## WAIMAKARIRI DISTRICT COUNCIL

### TECHNICAL MEMO

**SUBJECT:** Development of road width standards in Proposed District Plan

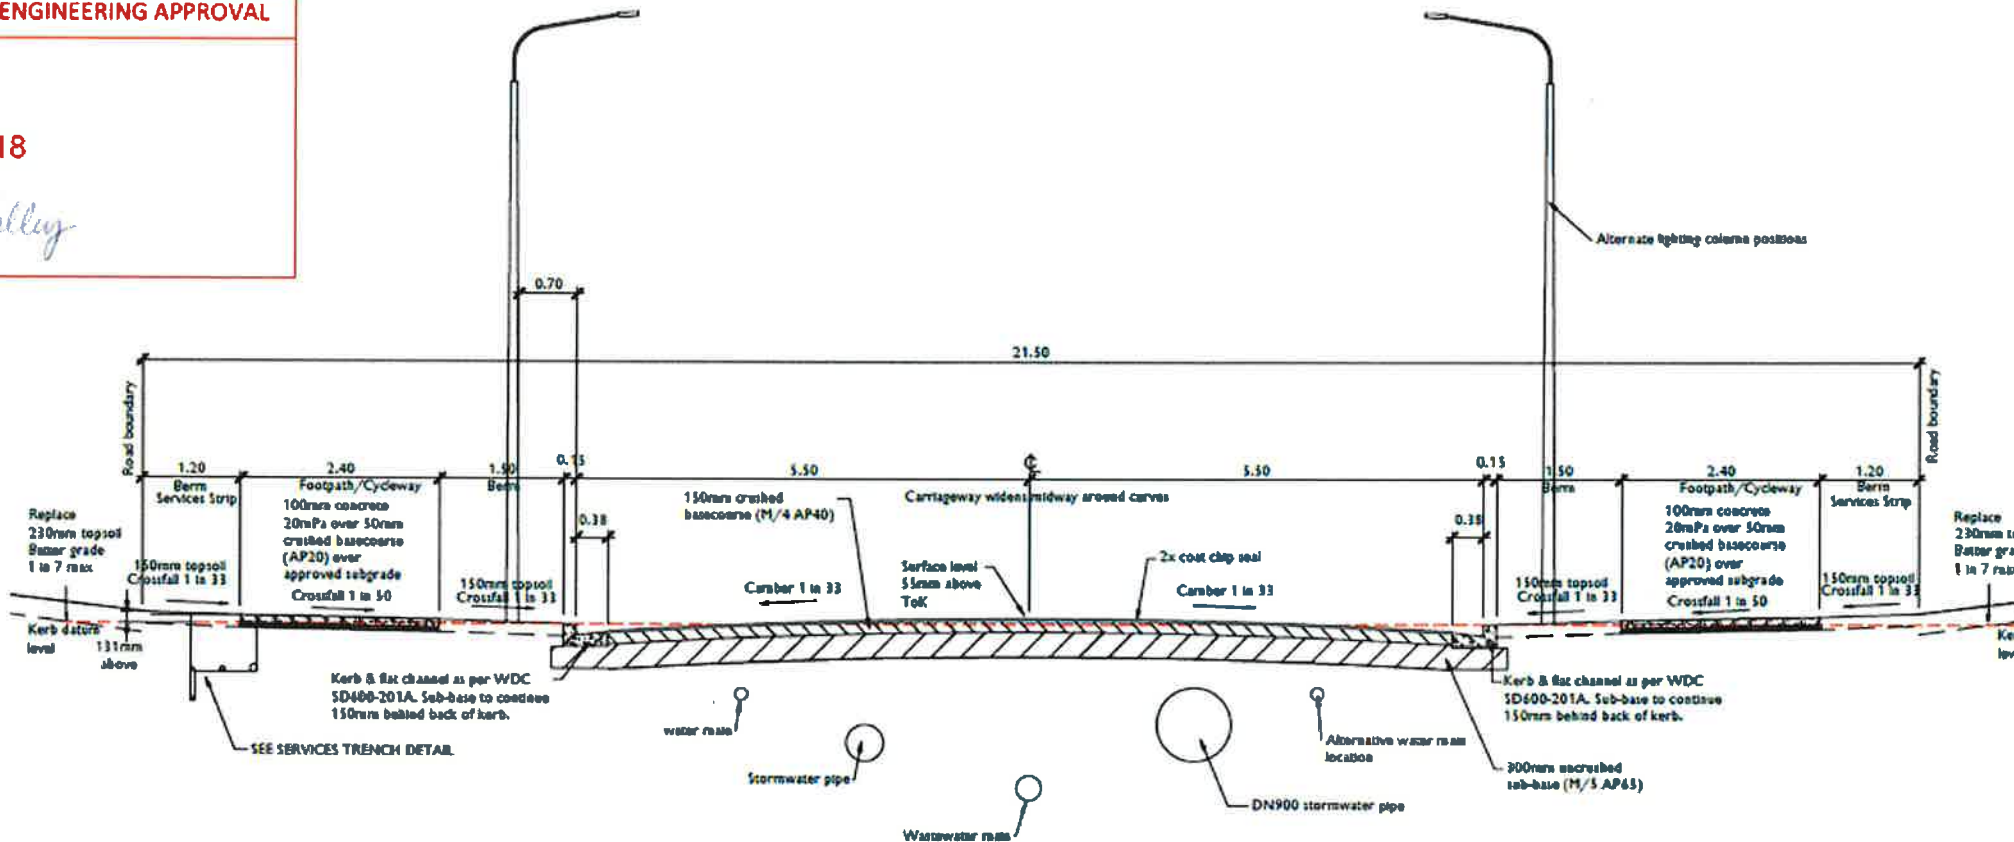
Thank you for that. For local roads, what is the requirement for footpaths (width and number)?

In Table 1, the collector roads (and arterial roads potentially) are the ones where we start to have problems with the minimum width. I am pretty sure I raised this back in the TAG as well. With 11.4m of the legal width taken up by traffic lanes (6.4m) and parking (5m – assuming 2 parking lanes but this is not clear in Table 1), the remaining 8.6m is not enough for cycle lanes, footpaths, street trees and services.

Did the Stantec report include a cross section of the typical layout for a collector road to ensure that there is sufficient space for features outside of the carriageway?

From the work done on Townsend Road, the minimum legal width required is 21.5m for an urban collector road and this is with a shared path, 2x3.3m traffic lanes, and 2x2.2m parking lanes. If an on-road cycleway were required plus a 1.5m footpath, the legal width would have had to be greater yet to accommodate street trees and services. A cross section is below for your reference. Note street trees are required to be located within the 1.5m berm closest to the carriageway. We even had to compromise with this design as there are services beneath the footpath, which is not a desired outcome.
